NCSX RFD <i>Part I</i>	Number: 14-019	RFD Description: Adding Lifting Holes in Poloidal Break Shims
Initiator: Mike Giffith		Organization: MTM
List of Impacted Documents: (<i>Specification, MIT/QA Plan, SOW, drawing, etc.</i>) <ul style="list-style-type: none"> • SE141-048 (MC Poloidal Break Shim Assembly Type-A) • SE141-058 (MC Poloidal Break Shim Assembly Type-B) • SE141-078 (MC Poloidal Break Shim Assembly Type-C) 		
Cost Impact: (<i>If none, so state</i>) : NONE		
Schedule Impact: (<i>If none, so state</i>: NONE		
Quality Impact: (<i>If none, so state</i>): Incorporation of these proposed changes will improve MTM manufacturing processing of remaining MCWFs not yet shipped.		
State Requirement Deviation is Requested For: (<i>Specification, MIT/QA Plan, SOW, drawing, etc.</i>): Revise identified drawings to provide lifting holes in Poloidal Break Shims.		
Full Description of the Deviation Requested: (<i>Use continuation pages, e-mails, letter, sketches, etc. as needed and include amplifying information as appropriate to support deviation request.</i>) To add lifting holes in the poloidal shims as per the attached e-mail request from Mike Griffith. Will only impact MCWFs not yet s

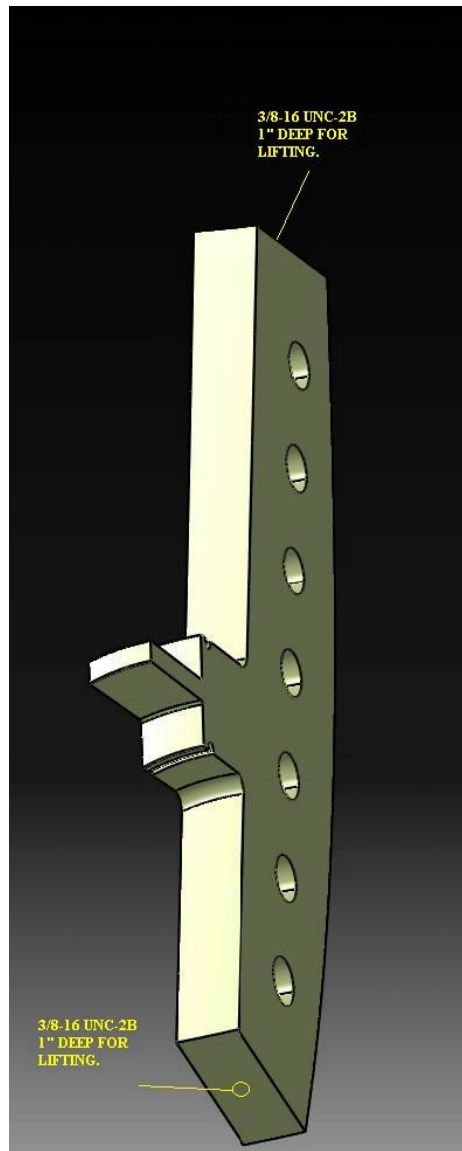
In order to assist in the intermediate and final assembly of the poloidal break shims in the remaining C's and in all of the A and B shims, we are requesting the addition of a 3/8-16 hole in both ends of the shim to be used for lifting. The drawing below is a C shim showing the approximate location of the holes. Please review and forward this request to PPPL. Thanks.

The lifting holes would be incorporated into C6 and all of the A and B shims. C5 is beyond this. Thanks.
